DEPARTMENT OF THE ARMY

U.S. ARMY LABORATORY COMMAND
MATERIALS TECHNOLOGY LABORATORY
WATERTOWN, MASSACHUSETTS 02172-0001

6 November 1992

This is a request for modification to the Reactor Decommissioning Plan for the U.S. Army Materials Technology Laboratory Research Reactor, Revision 1, Dated October 1991. Specifically, to modify sections 3.4.6, Basement Sumps and, 3.4.7, Gamma Facility and Storage Tubes. This modification will not require the removal of the steel liners from the gamma facility or sumps, the floor drains and connecting lines or the storage tubes unless they cannot be decontaminated to the levels specified in Reference 4 to the Decommissioning Plan.

Figure 3-8. Plan view of the AMTL Reactor basement floor.

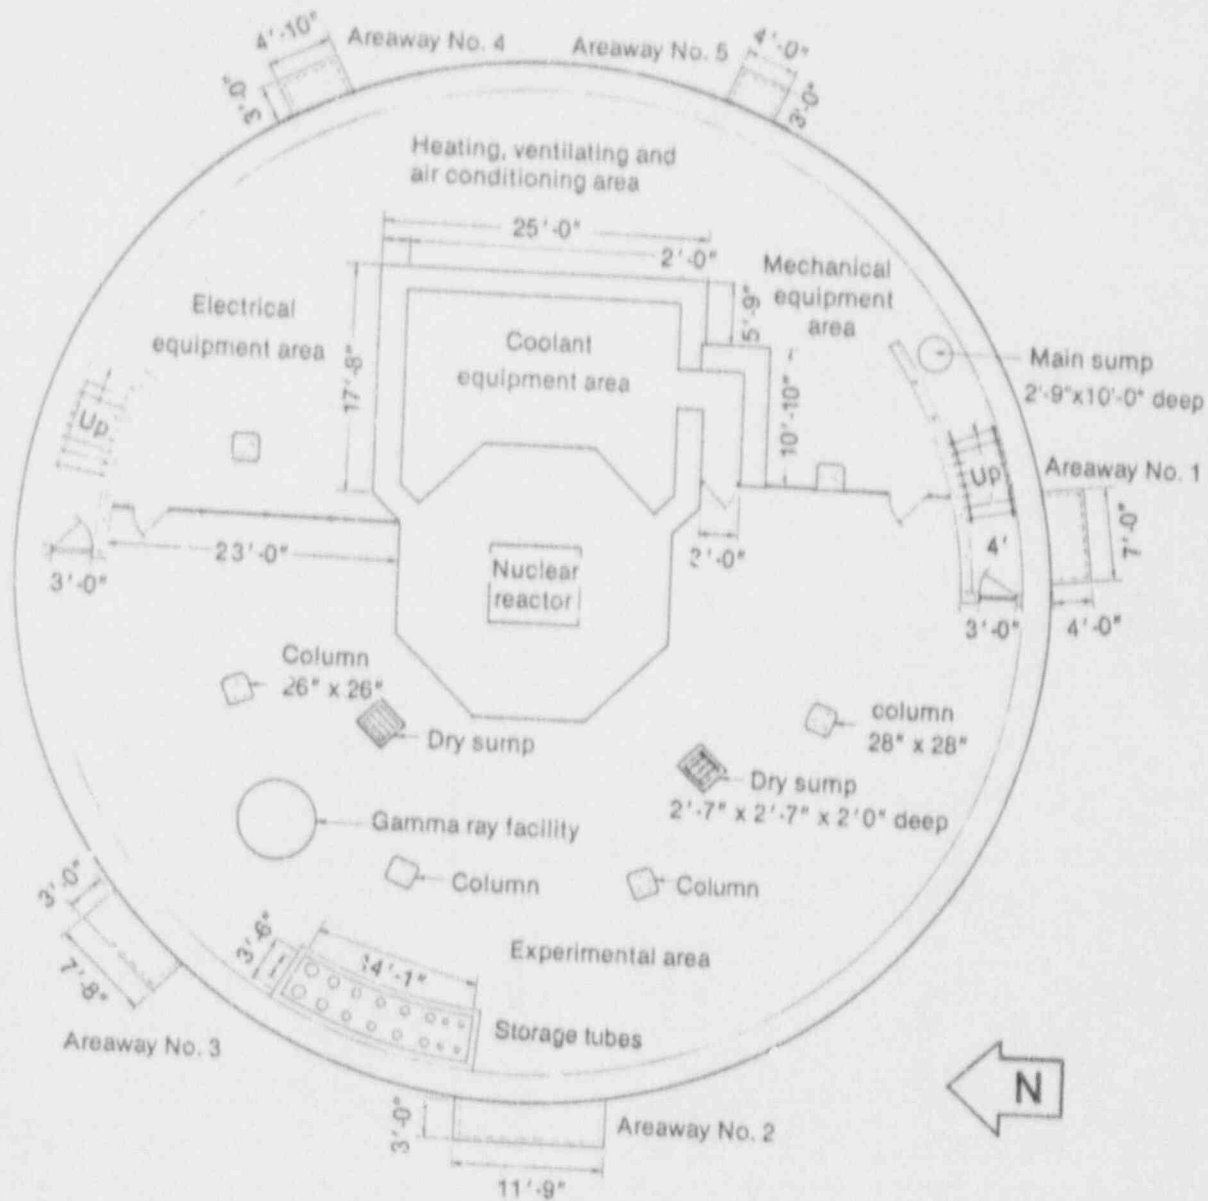
This proposed modification to the Decommissioning Plan does not increase the probability of contamination being released. The welded steel liners do not permit the passage of water to the substrate. The storage tubes, although not lined with steel, show only trace levels of contamination. Post-decontamination/termination surveys will consist of:

This request for modification of the plan is being made because survey results for these structures show incidental levels of activity. There is no indication of contamination on the substrate concrete. Any activity leached into the concrete substrate or remaining on the structures will be identified during the termination survey.

The two basement dry sumps (Figure 3-8) shall be removed by cutting the steel liners away from the concrete. The concrete will then be surveyed and chipped away as needed to remove contaminated materials.

The floor drains and connecting lines shall be chipped out from the drain inlet to where the lines enter the sump.

The sump pump shall be removed, the sump liner cut away from the concrete, and concrete removed, as needed, and materials disposed of as surveys and analyses dictate.

The gamma-ray facility (Figure 3-8) steel liner and storage rack shall be cut away from the concrete and the concrete surveyed and scabbled as needed to remove contamination. The storage tubes (Figure 3-8) shall be removed using coring, cutting, or other methods chosen by the contractor to separate the tubes individually or in groups from the basement floor.

The two basement dry sumps (Figure 3-8) shall be decontaminated. If decontamination efforts are unsuccessful at reducing contamination levels below those specified in Reference 4, all or portions of the steel liner will be removed and any contaminated concrete chipped, scabbled or removed as needed.

The floor drains and connecting lines shall be decontaminated, as required. If the post-decontamination survey shows levels in excess of the levels specified in Reference 4, any contaminated floor drains or contaminated connecting lines will be removed and the concrete chipped away as needed to remove the contaminated materials. In addition, any floor drains and connecting lines will be removed if they cannot be adequately surveyed.

The sump pump shall be removed and the sump decontaminated. If decontamination efforts are unsuccessful at reducing contamination levels below those specified in Reference 4, all or portions of the steel liner will be removed and any contaminated concrete chipped, scabbled or removed as needed.

The gamma facility storage rack shall be removed and the gamma facility shall be decontaminated. If decontamination efforts are unsuccessful at reducing contamination levels below those specified in Reference 4, all or portions of the steel liner will be removed and any contaminated concrete chipped, scabbled or removed as needed.

The beam tube storage tubes shall be decontaminated, as required. If the post-decontamination survey shows levels in excess of the levels specified in Reference 4, the contaminated portion of the storage tubes will be removed and any contaminated concrete chipped away as needed to remove all contaminated material.
